STAFF REPORT
COMMUNITY DEVELOPMENT DEPARTMENT

SUBJECT: H-2021-0080
 Verona Live/Work – CUP

Conditional Use Permit for ~~16~~ 14 vertically integrated residential units within ~~four (4)~~ three (3) buildings on 1.75 acres in the L-O zoning district.

A. Site Plan (date: January 2022 ~~10/6/2021~~) (NOT APPROVED)

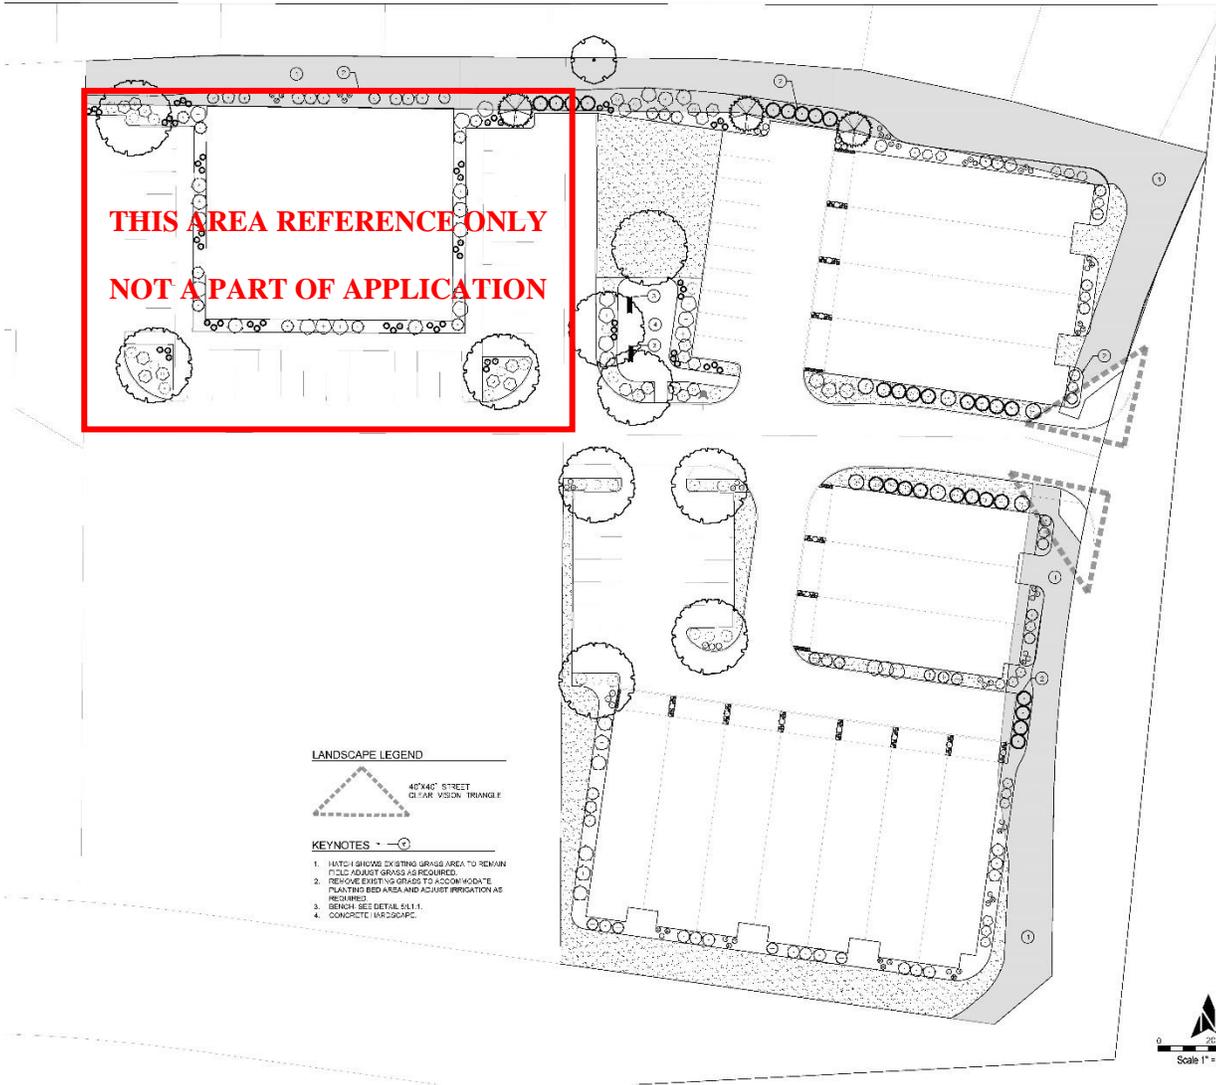
The submitted site plan shows the drive aisles adjacent to the garages as 20 feet wide which does not comply with UDC 11-3C-5 standards for two-way drive aisles. A two-way drive aisle, applicable throughout the site, requires a minimum width of 25 feet. The Applicant should revise the plans to show compliance with this standard at the time of Certificate of Zoning Compliance (CZC) submittal.

The site plan shows multiple drive aisles off of the main east-west drive aisle for access to the proposed vertically integrated units and the two-car garages. Staff anticipates the two access points shown on the site plans would be needed for safest and most efficient flow of traffic for this proposed project despite the future office building to the west not being a part of this project. Because of this, Staff is recommending a condition of approval to construct the northern portion of this drive aisle with this project to ensure adequate traffic flow for the site regardless of the timing of development of the office site shown west of the subject sites.

The submitted plans do not show any additional sidewalk connections from the front of the buildings to the existing sidewalks, as required in UDC 11-3A-19. Staff finds this to be a missed opportunity to activate the building frontage with the adjacent streets for the commercial suites. Therefore, consistent with Staff's additional recommendations to add a separate commercial door on the front façade of each unit, Staff is recommending additional 5-foot wide sidewalks are constructed from the front of the units facing public streets (14 of the 16 units). Because of the overall design of the units abutting each other in a mirrored format, Staff is acceptable to shared connections to the attached sidewalks so long as each unit entrance has a sidewalk connection to the shared connection. Please see exhibit below for an example:

- a. All drive aisles shall be a minimum of 25 feet wide, per UDC 11-3C-5 standards.
 - b. For the facades facing W. Milano Drive and N. Cortona Way, depict additional 5-foot wide sidewalks connecting from these building entrances to the existing sidewalks along the public streets, similar to what is shown in the submitted color site plan image.

- d. ~~Remove the two units not along the adjacent streets in lieu of additional parking and some usable common open space for the development.~~
 - e. Move the northern four (4) units approximately three (3) feet to the north to accommodate an extension of 5-foot wide sidewalk and 5 feet of landscaping along the south side of this building from Cortona Way to the plaza area in the interior of the site.

- 9. The east-west drive aisle depicted on the site plan(s) that connects from N. Cortona Way, to the existing north-south drive aisle on parcels R9010670065 & R9010670015 shall be constructed with the first phase of this project to ensure adequate traffic flow for the site.

B. Landscape Plan (date: 9/30/2020 January 2022)

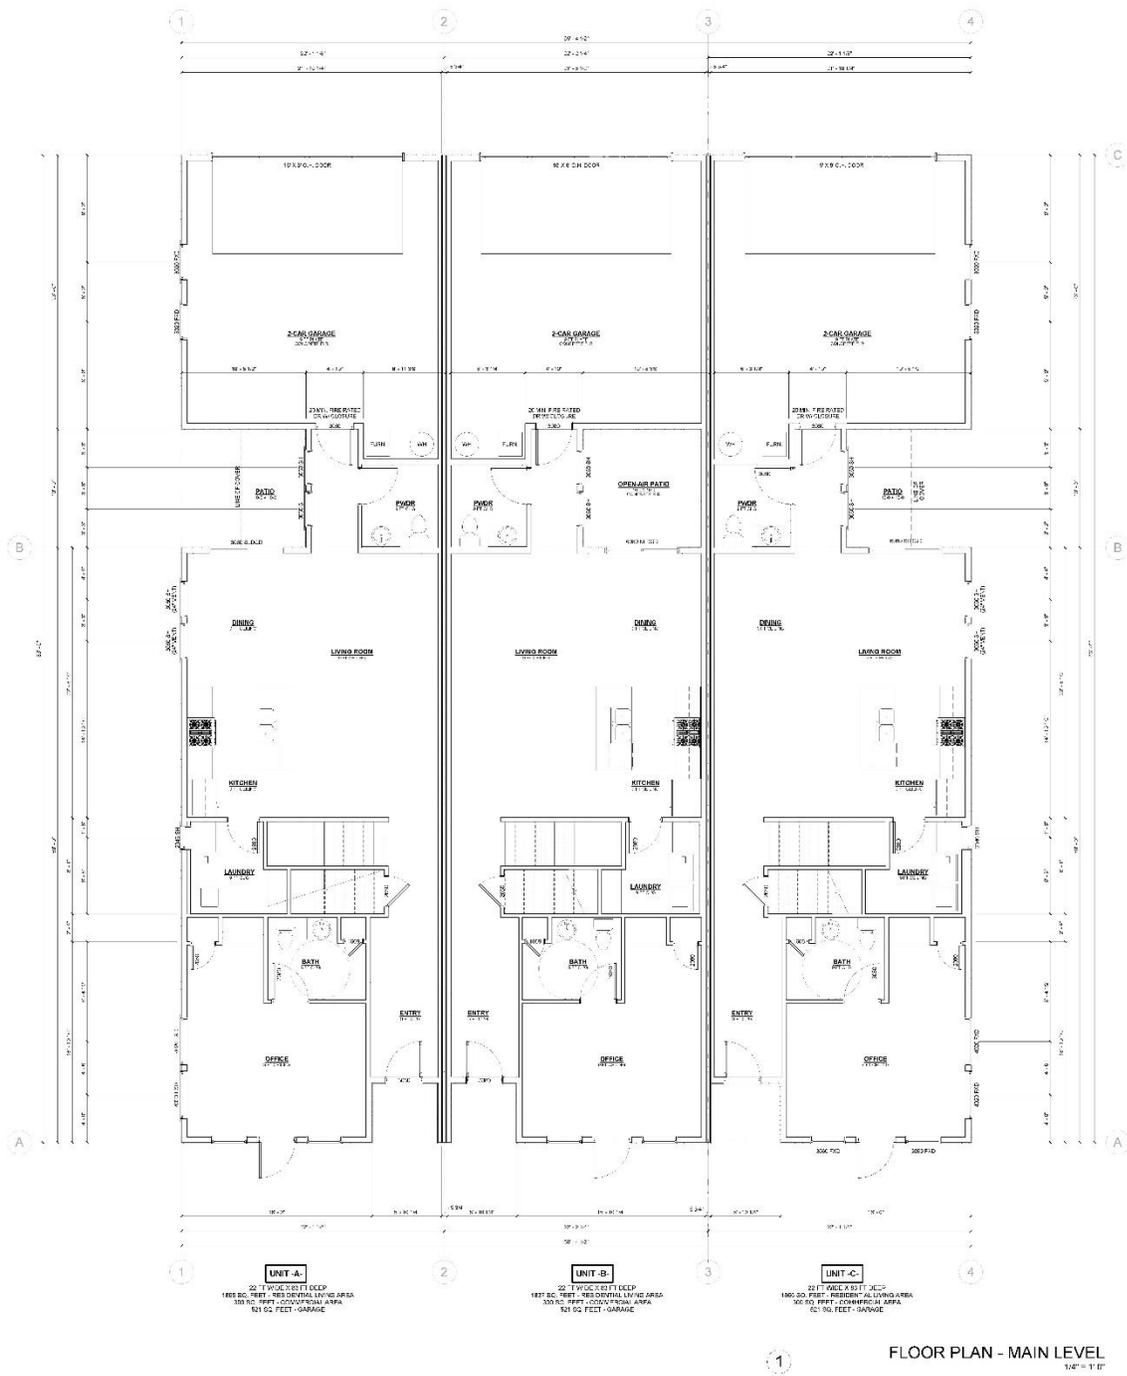
All required street buffers are existing and comply with code requirements. The submitted landscape plan depicts the required 20-foot wide use buffer along the north property boundary but does not show the required number of trees. According to the aerial imagery, there appears to be existing and mature trees in this buffer but this is not depicted on the plans. The existing landscape conditions should be added to the plans with the future CZC submittal.

The required parking lot landscaping appears to be compliance with UDC requirements except for the area adjacent to the parking lot along the west boundary on the south parcel. D. This should also be revised with the future CZC submittal.

6. The landscape plan(s) submitted with the Certificate of Zoning Compliance application shall depict the following revisions:
 - a. Depict all existing landscaping on the subject sites to ensure compliance with UDC standards.

- b. Depict at least 5 feet of landscaping and the required number of trees along the west project boundary and adjacent to the proposed parking lot on the south parcel (3042 W. Milano Drive).

- c. Depict the additional 5-foot wide sidewalks as noted above.
 - d. ~~Depict the shared plaza as noted above with appropriate landscaping elements.~~

C. Conceptual First-Floor Plans (dated: February 2022)

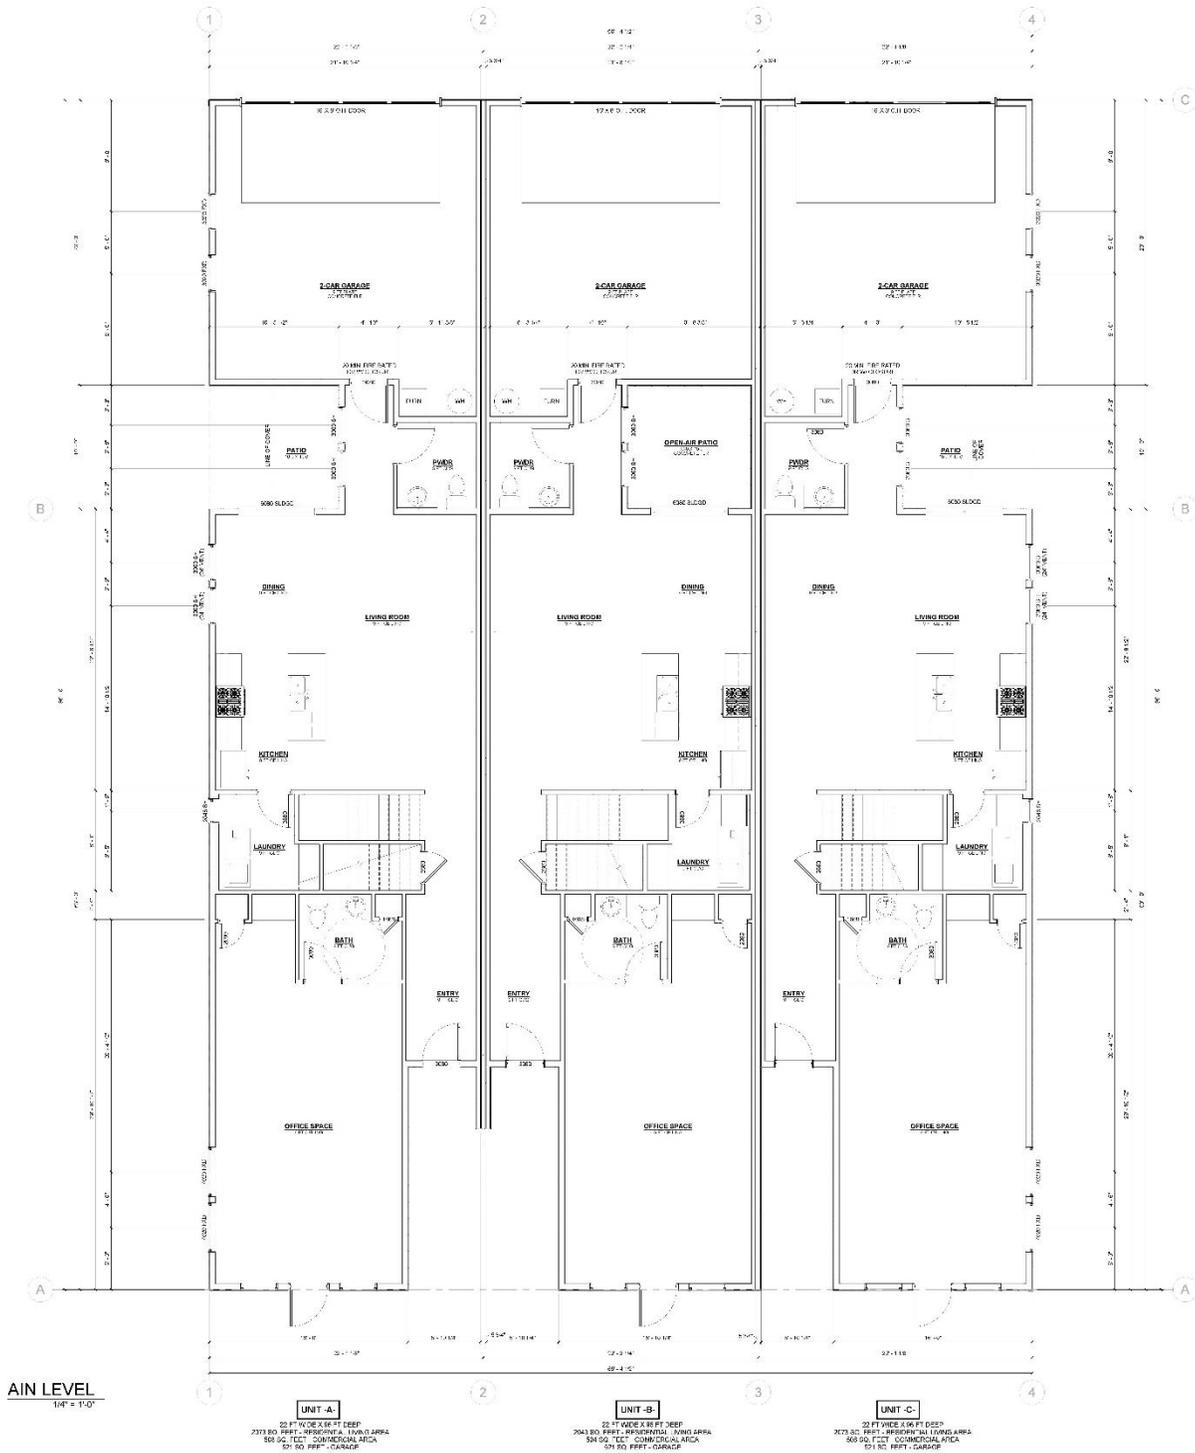
However, the proposed unit design is what creates concern and Staff finds it does not fully meet the noted definition of Vertically Integrated as currently proposed. The submitted floor plan shows a relatively small commercial suite that has minimal storage space for inventory, no separate room for meetings, and no outdoor patio space to help activate the commercial frontage. Staff is concerned this small space could be rented out as a separate residential unit without the City being the wiser OR would become an office for the residence and not serve the nearby neighborhood as intended with the commercial component of vertically integrated residential projects. The proposed size of the commercial spaces in each unit will likely not support many of the allowed uses noted in the specific use standards for this use. This furthers Staff's concern that these units may become standalone residential, which is not an allowed use in the L-O zoning district.

In order to help with some of the concerns noted, Staff is recommending the following revisions to the plans: 1) expand the commercial area of the units to potentially encompass the entire first level; 2) remove the first exterior door to help delineate the commercial and residential areas of the units by creating two exterior facing doors; one for the residential, and one for the commercial suite; and 3) remove the two (2) units that frame the hard corner of W. Milano Drive and N. Cortona Way to incorporate a shared plaza space similar to what exists in the commercial area on the south side of McMillan in Bridgetower Crossing. With the addition of outdoor patio space/shared patio space the commercial component of this development would help activate some of the commercial spaces. Additional and more specific recommendations can be found under the elevation analysis below and in the conditions of approval in Section X.A.

- 8. ~~Prior to the Planning and Zoning Commission hearing, the conceptual floor plans shall be revised as follows:~~
 - a. ~~Expand the commercial areas of at least some of the units to help the viability of the commercial component of this project.~~

- b. ~~Remove the first exterior door to help delineate the commercial and residential areas of the units by creating two exterior facing doors; one for the residential, and one for the commercial suite.~~
